**Amendments C192 and C193  
Greater Shepparton Planning  
Scheme and Planning Permit  
2016-269**

**Proposed Shopping Centre  
Development**

177-193 Numurkah, Shepparton.

traffic: evidence

**Figure 3.2 Numurkah Road / Hawkin Street Intersection**

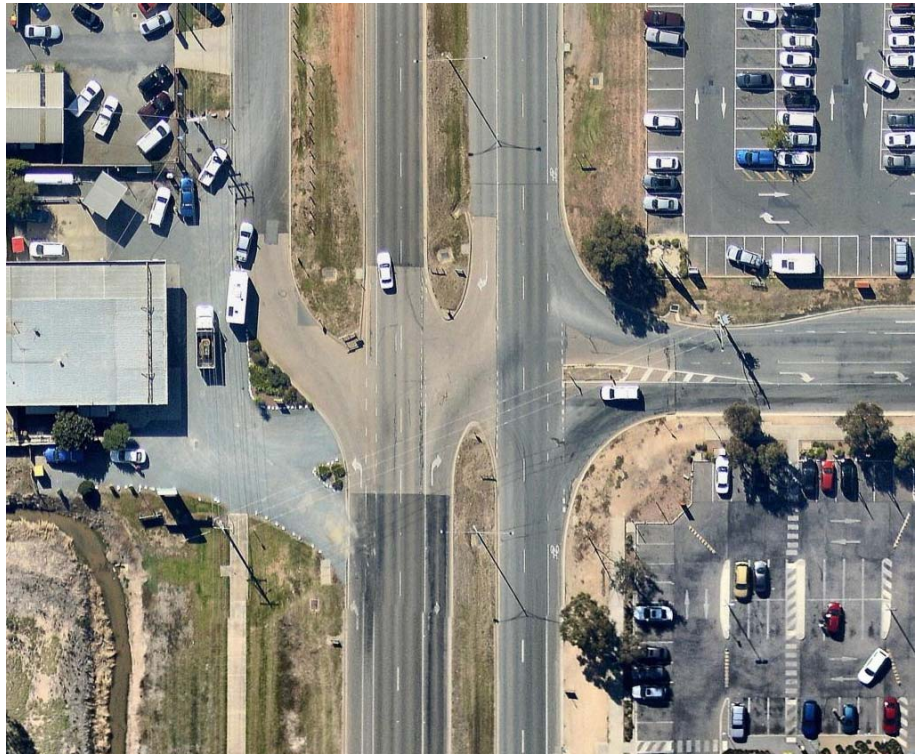
- 2032 Stage 1 and 2 Development (Signalised)
- 5.4.3 I have assessed the SIDRA outputs contained in the Stage 2 reports and note that there are minor discrepancies in the modeling undertaken when compared to the VicRoads endorsed plan shown in Figure 3.2., specifically:

Figure 4.2 Proposed Concept Signal Plan - Stage 1 Application.

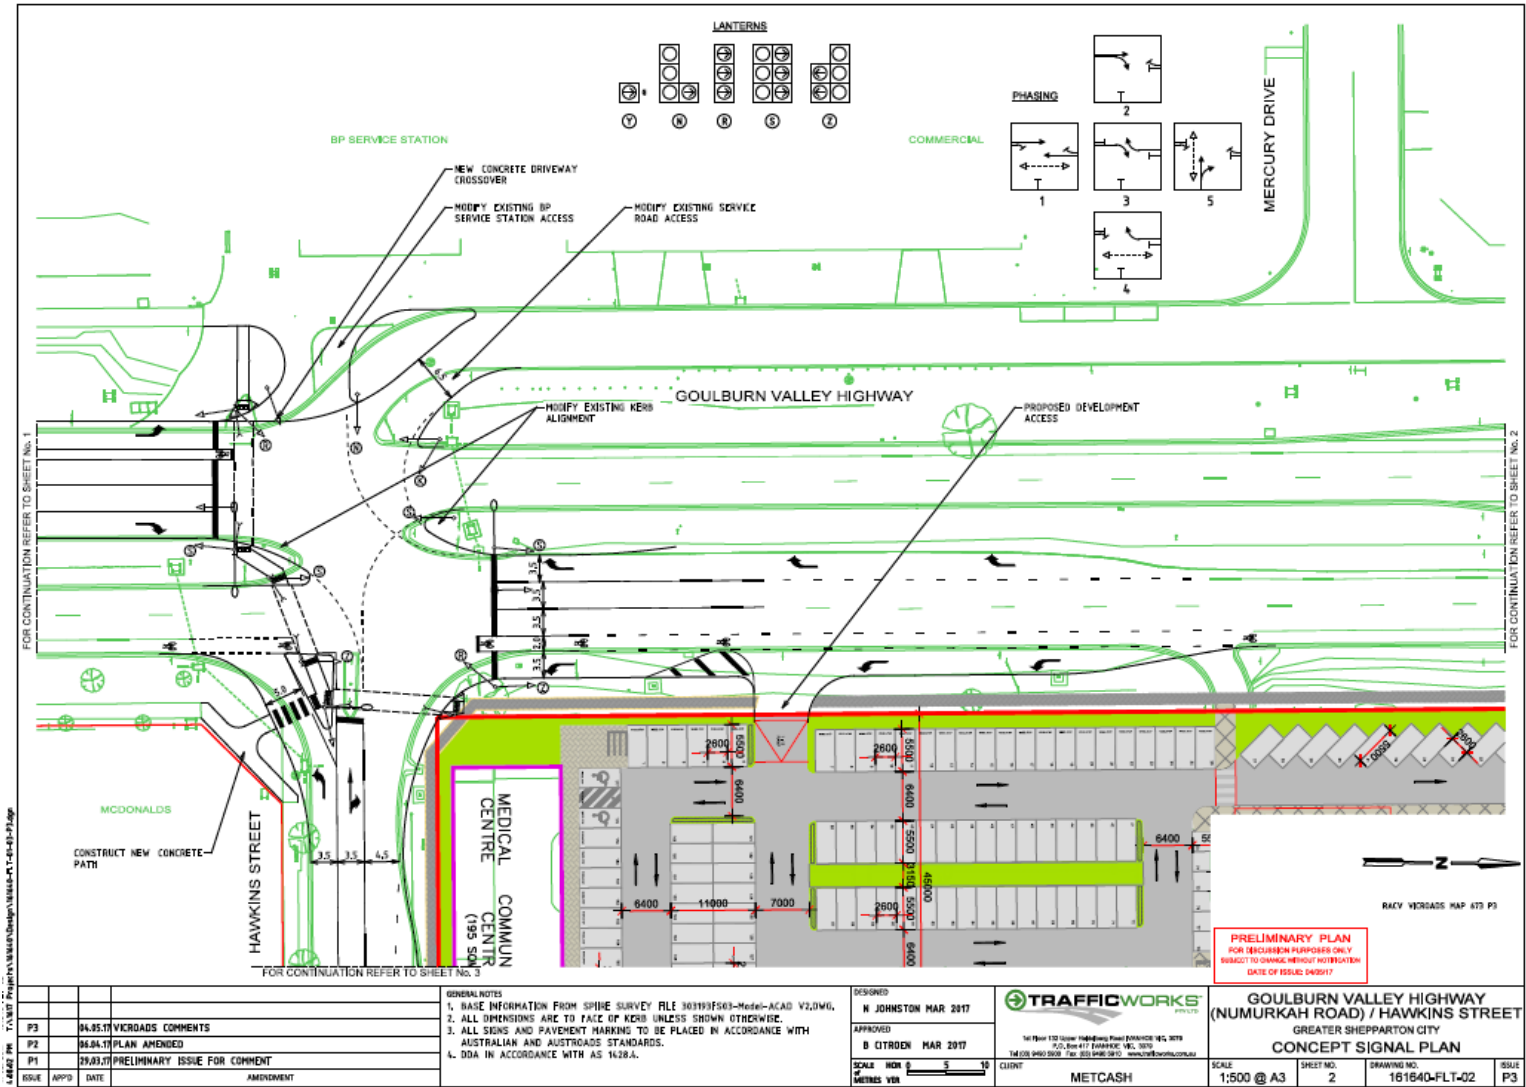
4.2.8 The proposed concept plan for the proposed traffic signals at the intersection of Hawkins Street and Numurkah Road is shown in Figure 4.2.

- a. Traffic Signal at Numurkah Road/Hawkins Street intersection and generally in accordance with Trafficworks Concept Signal Plans Drawing No.s 161640-FLT-01, 161640-FLT-02 & 161640-FLT-03 Issue P2 dated 06/04/2017 including street lighting to Category V3 Standard.

**Figure 5.2 – Hawkins Street Frontage – Access Arrangements (Source: Stage 1 TIA)**

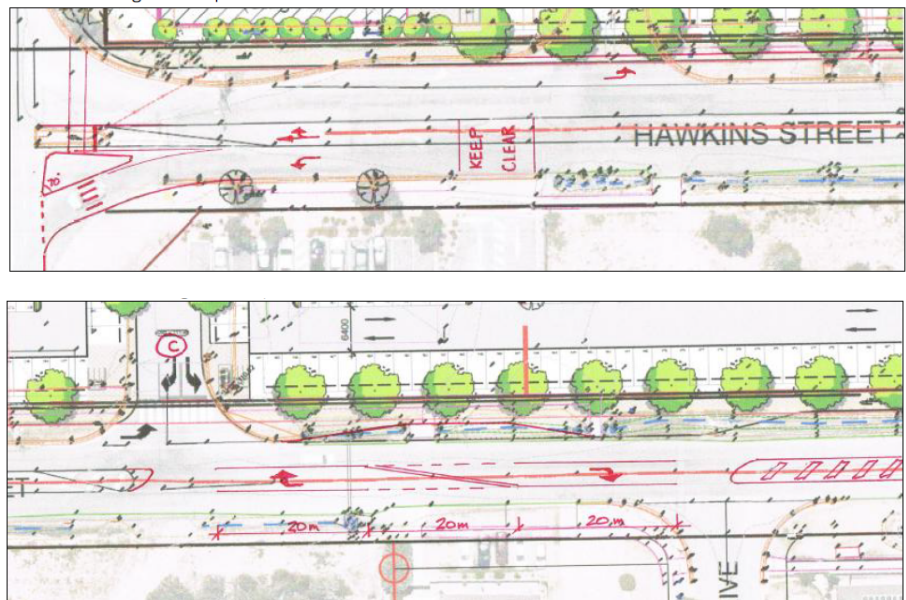
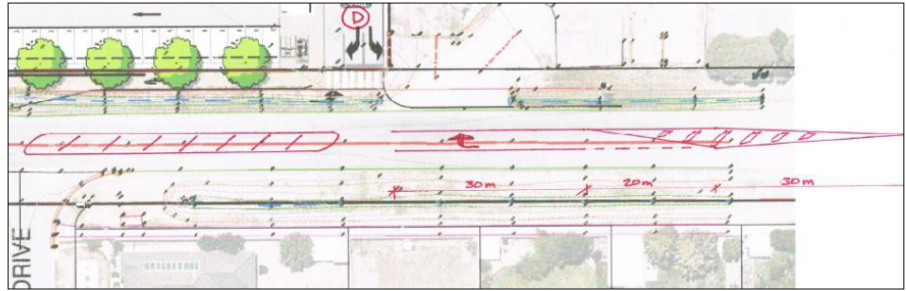
- 5.5.1 The signalisation of the Numurkah Road / Hawkins Street, together relocation of the existing access to the site from Hawkins Street and a new access adjacent to the eastern boundary, will require widening of Hawkins Street and reconfiguration of the access arrangements to the McDonalds site to the south and the Sali Drive intersection, a local street running to the south opposite the site.
- 5.5.2 Sketches showing the recommended configuration of Hawkins Street along the site frontage and the proposed access points is shown in a series of sketches contained within the Stage 1 application report and reproduced in Figure 5.2

- 5.5.3 The proposals include:
- Provision of separate left and right turning lanes into the site from each of the proposed access points
  - Incorporation of a right turn lane into Sala Drive accommodated between the access points

- Widening on the northern side within the road reserve to accommodate the proposed left turn lanes
  - Widening on the approach to the Numurkah Road intersection to provide for two approach lanes, including provision of a left turn slip lane into Numurkah Road as required by VicRoads

- 5.5.6 In my opinion, these matters can be dealt with appropriately as a condition on any permit issued for Stage 1 and consequent approval of functional plans showing the layout of Hawkins Street to the satisfaction of Council (as the road authority).
